**Professional Review & Comment of the
Draft Environmental Impact Statement
and Supporting Documents
Related to Surface Water Impacts of the Proposed
PennEast Pipeline Project**

September 5, 2016

**The Delaware Riverkeeper Network
925 Canal Street
Bristol, PA 19007**

**Michele C. Adams, P.E. Water Resources Engineer
and Marc B. Henderson, P.E. Water Resources Engineer
and Chelsea Fitzpatrick, Water Resource Designer
Meliora Design
259 Morgan Street
Phoenixville, PA 19460
(610) 933-0123**

Figure 2: Erosion and Sediment Control Plan Alignment Sheet 81 MP 40.0 to MP 40.5

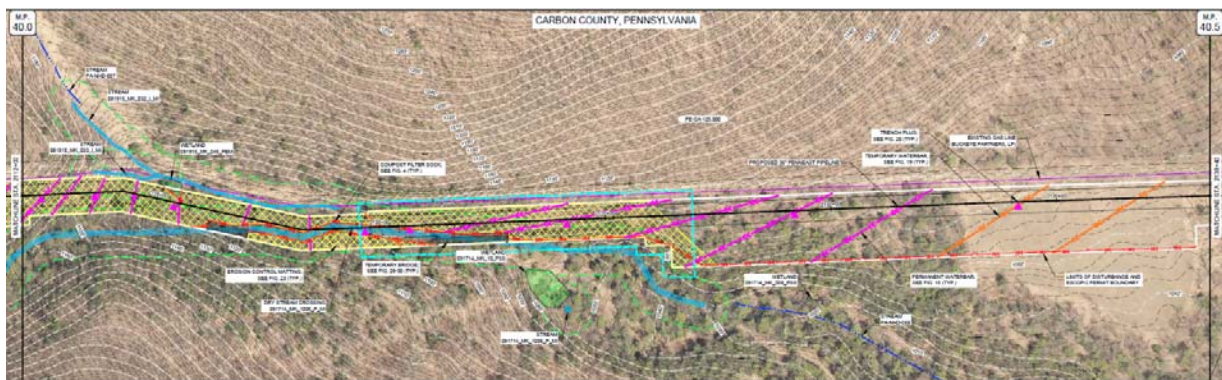
This is a forested stream valley where the pipeline and workspace will run through and along (parallel to and on top of) two small streams nestled in the valley between very steep wooded hillsides, as shown on the Erosion and Sediment Control Plan Alignment Sheet 81. This is a good example of a stream crossing area with multiple site constraints where a dry stream crossing and wide disturbance area will adversely impact water quality during and after construction. However, this information and the magnitude of the existing site constraints is not clearly communicated in the PennEast application documents, or addressed by FERC in the DEIS. The DEIS fails to comprehensively consider the site specific environmental constraints in allowing a dry cut and wide area of disturbance through this stream valley (and on top of the existing stream). This is not merely a matter of crossing a stream, the stream channel itself (for a distance of approximately 188 feet according to Table 2A-1) will need to be recreated after pipeline construction.

The extent of site constraints and stream and wetland impact can be seen on the Erosion and Sediment Control Alignment Sheet. The pipeline and its workspace are located on and immediately parallel to the small streams in this steeply sloped forested valley for over 1,200 feet. There is an existing pipeline through this valley, however, the PennEast Pipeline and right-of-way are adjacent to the existing pipeline, with the new pipeline centerline shown as 50 feet from the existing pipeline centerline. The proposed waterbars on the western portion of the pipeline right-of-way show a disturbance area of over 200 feet in width, conveying flows and discharging onto very steep slopes (greater than 30%) that discharge into the stream and wetlands. The waterbars themselves are steep for flow conveyance (4-5%).

- The pipeline and workspace are on top of or immediately adjacent to the parallel small streams for over 1,200 feet.
- The slopes in portions of the project area are classified as “Rugged Terrain” with slopes of 47% according to the updated Table 1.5-6 Rugged Topography in the PennEast Response to FERC Data Request 14.

- The soils are indicated as “very stony loam” and moderately erosive in Resource Report 7, Table 7.1-2 “Soil Units Crossed by the Pipeline and Important Soil Attributes.”

- The soils are indicated to have “Poor” revegetation potential.
- The area includes underlying geology with potential shallow bedrock and may require blasting according to Table 1.5-8 “Areas Where Blasting May be Required” in PennEast response to FERC Data Request 61.

- There are three wetlands in immediate proximity to the pipeline, two of which will be in the construction right-of-way.
- The pipeline construction will impact hydric soils.

- The existing conditions are forested.
- A 150-foot riparian buffer is required along EV streams in Pennsylvania, and will be removed for a distance of over 1,200 feet.

The DEIS fails to consider the multiple site specific constraints within this stream valley, and fails to consider the likelihood that these constraints will contribute to permanent reductions in in-stream water quality. The DEIS fails to consider options such as crossing this area via a boring or HDD, and reducing the workspace and pipeline right-of-way to coincide with the existing pipeline.

Figure 3: Erosion and Sediment Control Plan Alignment Sheet 67 MP 33.0 to MP 33.5

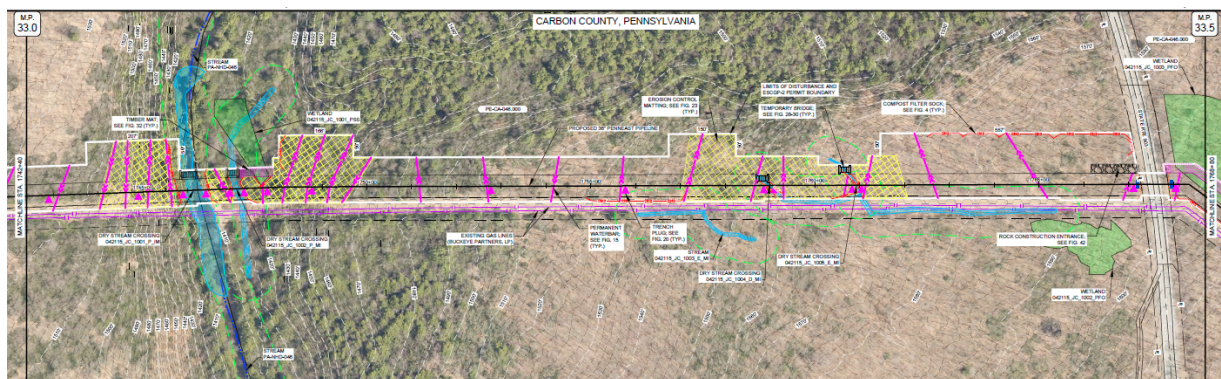
This is a forested stream valley in Hickory Run State Park where the pipeline and workspace will cross High Quality Mud Run (with a stream width of over 60 feet and a drainage area of almost 17,000 acres), as shown on the Erosion and Sediment Control Plan Alignment Sheet 67. We visited this area on July 18, 2016.

This is another example of a stream crossing area with multiple site constraints where a dry stream crossing and wide disturbance area will adversely impact water quality during and after construction, as can be seen on the Erosion and Sediment Control Alignment Sheet 67. From the north, the pipeline traverses down steep (40%) rocky slopes before crossing Mud Run and a small stream to climb the steeply sloped hillside. There is an existing pipeline through this valley, however again, the PennEast Pipeline and right-of-way are adjacent to the existing pipeline, with the new pipeline centerline shown as 50 feet from the existing pipeline centerline, creating an even wider swath of disturbance through this forested State Park. The existing waterbars from the existing pipeline show signs of erosion and sediment transport. There is easy public access to this area from State Route 903, and it appears that both pedestrians and vehicles traverse to the existing right-of-way and waterbars.

- The pipeline and workspace are adjacent to the existing pipeline and will create a wider swath of disturbance through Hickory Run State Park.
- The slopes in portions of the project area are classified as “Rugged Terrain” with slopes of 40% according to the updated Table 1.5-6 Rugged Topography in the PennEast Response to FERC Data Request 14.
- The soils are indicated as “Meckesville very stony loam” and severely erosive.in Resource Report 7, Table 7.1-2 “Soil Units Crossed by the Pipeline and Important Soil Attributes.”
- The soils are indicated to have “Poor” revegetation potential. This can be seen along the existing pipeline.
- The area includes underlying geology with potential shallow bedrock and may require blasting according to Table 1.5-8 “Areas Where Blasting May be Required” in PennEast response to FERC Data Request 61. Observed stream conditions indicate a rock substrate.

- There is a forested wetland in immediate proximity to the pipeline, a portion of which will be cleared.
- The pipeline construction will impact hydric soils.
- The existing conditions are forested.
- The existing forested riparian buffer along Mud Run will be removed for a distance of approximately 200 feet on each side.

The DEIS fails to consider the multiple site specific constraints within this stream valley, and fails to consider the likelihood that these constraints will contribute to permanent reductions in in-stream water quality. The DEIS fails to consider options such as crossing this area via a boring or HDD, and reducing the workspace and pipeline right-of-way to coincide with the existing pipeline.

Figure 8: Erosion and Sediment Control Plan Alignment Sheet 70 MP 34.5 to MP 35.0

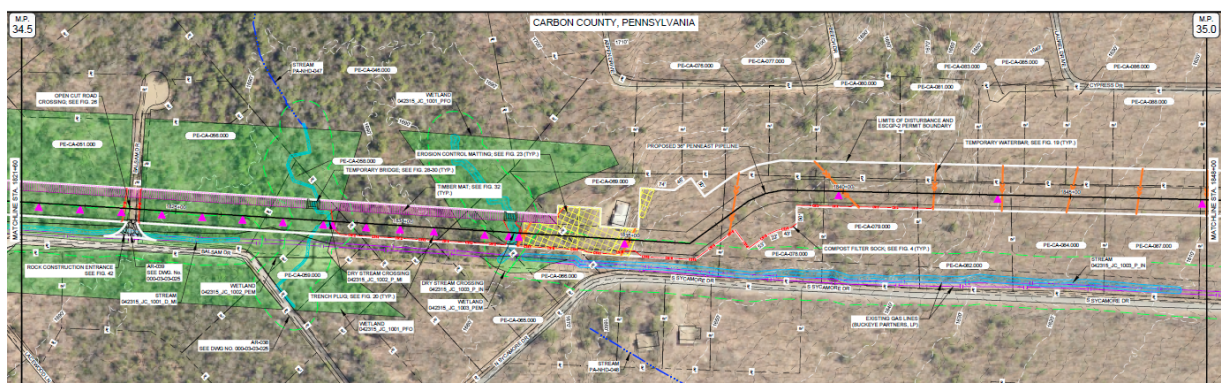
This is a heavily forested stream and wetland area in Mountain View Estates where the pipeline and workspace will include three stream crossings and run parallel to the stream, as shown on the Erosion and Sediment Control Plan Alignment Sheet 70. With property owner permission, we visited this area on August 4, 2016. Despite a dry summer with low rainfall, conditions were wet when we visited the site.

In this area, an access road will cross and be constructed on top of a small stream. The access road will be perpendicular to the pipeline, which runs adjacent to the stream for approximately 200 feet. The pipeline then crosses two additional streams and a wetland. Only two streams are listed in Resource Report 2, Table 2A-1 “Waterbodies Crossed by the Project in Pennsylvania” and updated Table 2A-1 in the PennEast application Response to (FERC) Data Request 19. The streams are listed as EV Wild Trout Waters. All crossings are proposed as dry crossings.

- The pipeline and workspace are adjacent to existing pipelines but will create a wider swath of disturbance as the PennEast pipeline is adjacent to and outside the right-of-way of the existing pipelines.
- The soils are indicated as “Papakating silty clay loam”.in Resource Report 7, Table 7.1-2 “Soil Units Crossed by the Pipeline and Important Soil Attributes.” This soil is moderately erosive.
- The soils are indicated to have “Poor” revegetation potential. This can be seen along the existing pipeline.

- There is a forested wetland in immediate proximity to the pipeline, a portion of which will be cleared.
- The pipeline construction will impact hydric soils.
- The existing conditions are forested.
- The existing forested riparian buffer will be removed for significant distances (approximately 200 feet) as the pipeline is parallel to the stream.

Again, the DEIS fails to consider the multiple site specific constraints within wooded wetland stream area, and fails to consider the likelihood that these constraints will contribute to permanent reductions in in-stream water quality. The DEIS fails to consider options such as crossing this area via a boring or HDD, and reducing the workspace and pipeline right-of-way to coincide with the existing pipeline.
